# Technical Service Bulletin

Mazda North American Operations  
Irvine, CA 92618-2922

<b>Subject:</b>  LIFTGATE SWITCH DOES NOT WORK	<b>Bulletin No.:</b> 09-004/22
	<b>Last Issued :</b> 08/08/2022

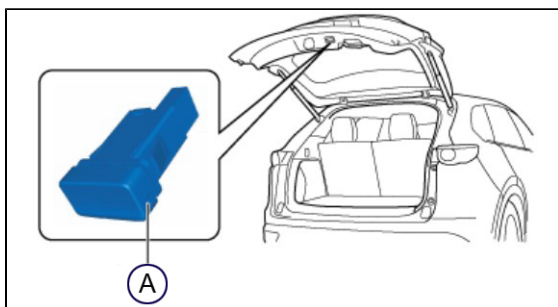
Some CX-5 and CX-30 customers may find that the liftgate does not close when pressing the power liftgate (PLG) rear switch (A) located on the interior liftgate trim. This may be caused by PLG switch corrosion. Water from a high pressure car washer and/or condensation may drip onto the switch connector and cause corrosion.

To eliminate this concern, the PLG rear switch has been modified with a waterproof connector.

**INSTRUCTIONS FOR WRAPPING THE CONNECTOR:**

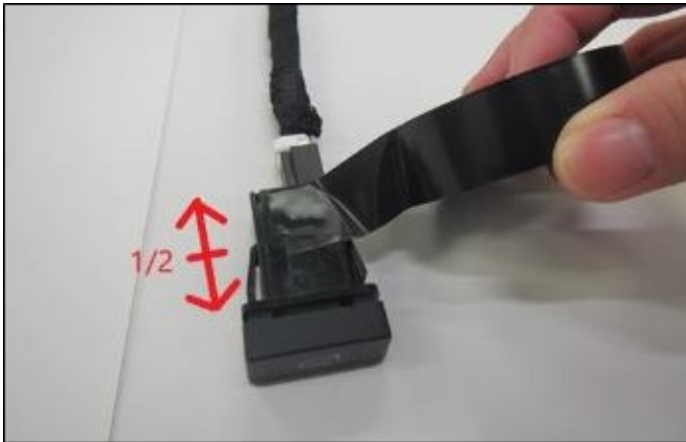
- While wrapping either upwards or downwards, use the half-overlapping method.
- To seal any possible gaps from water entry, stretch the tape a little to make it fit securely to the shape of the switch and coupler.
- In the image below, the thick foam rubber is not illustrated (the connector used for this photo did not have this part), but it is important as a position reference during the wrapping.

1. Start wrapping from the middle of the switch and continue upwards until the thick rubber foam and the border between it and the harness are completely covered.

2. After reaching the border between the thick rubber foam and the harness, cut the tape once. Then, start wrapping again in the reverse direction (i.e. start from where the tape was cut and stop at the middle of the switch). After cutting the tape once more, wrap upwards again to ensure no gaps are left.

3. Verify there are no gaps left.
